PLANNING DIVISION STAFF REPORT

January 22, 2018

Project Address: 1702 Monroe Street & 625 S. Spooner Street (District 13 – Ald. Eskrich)

Application Type: Planned Development Zoning Map Amendment & Demolition Permit

Figure 1: Proposed Building Related to TSS Zoning Setbacks

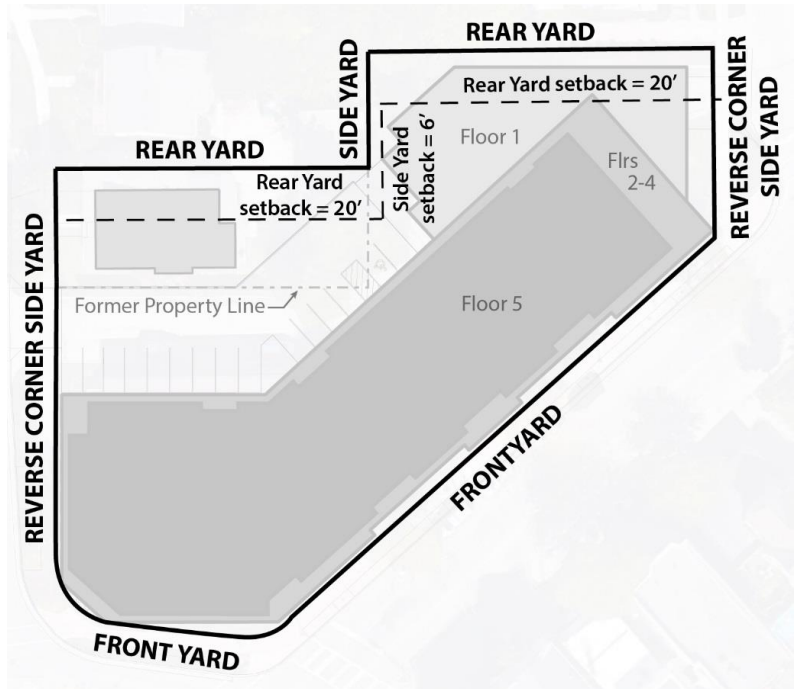
This standard further states that PD zoning shall also not also be allowed for “development that otherwise could not be approved unless the development also meets one or more of the PD objectives.” The Planning Division has concerns related to the building’s mass and placement as it would not meet the rear yard setbacks and stepbacks required in the aforementioned zoning districts. Such requirements are intended to provide an appropriate transition between commercial buildings and abutting residential buildings. Staff believes that this is an especially important consideration in areas such as Monroe Street where there are several blocks with similar transitions. The aforementioned Zoning districts would require a 20-yard building setback along the rear property line where only a six foot setback is proposed along the eastern side. While that portion of the building is only one-story, conventional zoning would not allow any building in that area (see Figure 1).

Figure 2: Proposed Building Related to the TSS District’s Rear Yard Height Transition (Note: The Location of the Transition Line is Approximate)

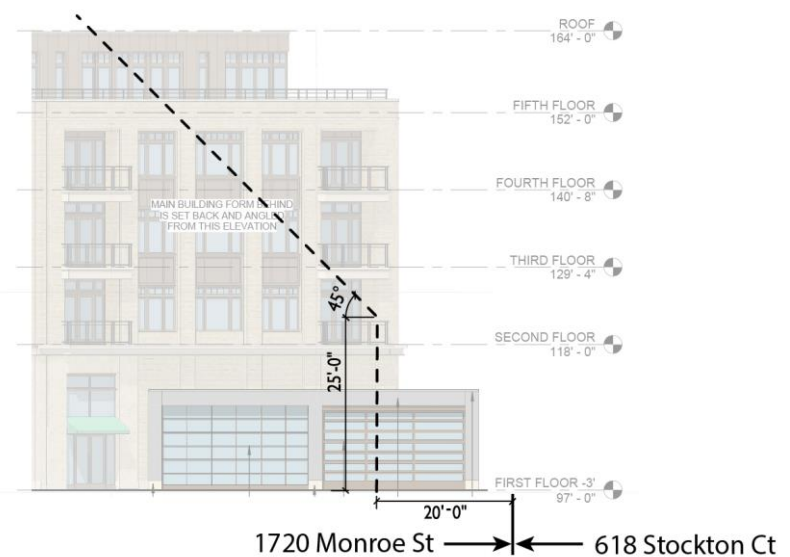
In a conventional mixed-use district, the building would also be required to be stepped back at a 45-degree angle above the second floor from the residential properties to the rear (see Figure 2). Under conventional zoning district, the applicant could request a conditional use approval to modify these stepback requirements, but in most cases of multi-story mixed-use redevelopment, even for three and four story buildings, the stepbacks have been adhered to.
